URGENT: MEDICAL DEVICE CORRECTION
Level 1® H-2 Pressure Chambers

29 July 2022

Smiths Medical is issuing this letter to notify you of a potential issue with specific Level 1® H-2 Pressure Chambers that are used with the Level 1® Fast Flow Fluid Warmers. This letter details the potential issue, the affected models, and the required steps to perform.

Figure 1: Location of Serial Number on H-2 Pressure Chamber

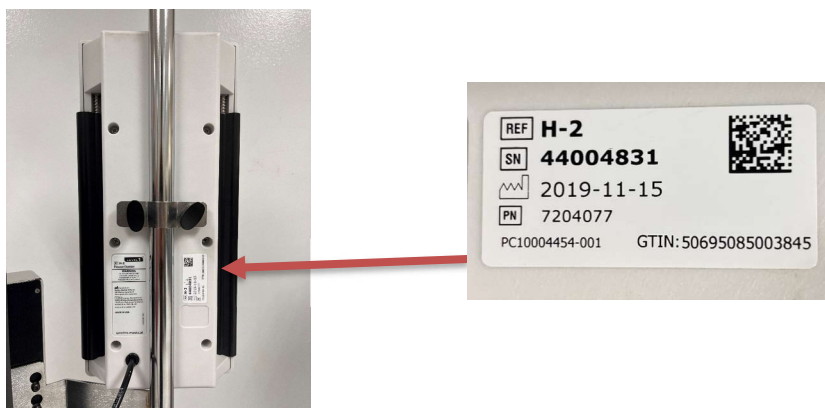
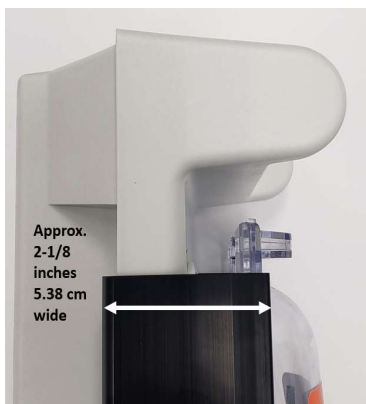
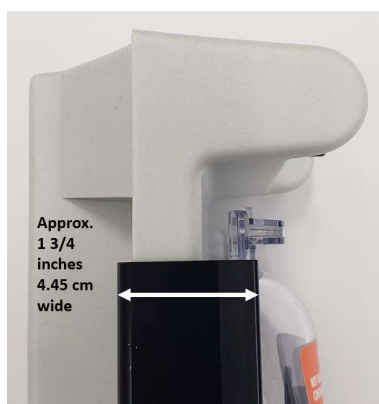
1. Identify all affected Level 1 H-2 Pressure Chambers in your possession:
 - a. Identify the Level 1 H-2 Pressure Chamber serial number (SN). Refer to Figure 1 below for the location of the device SN.
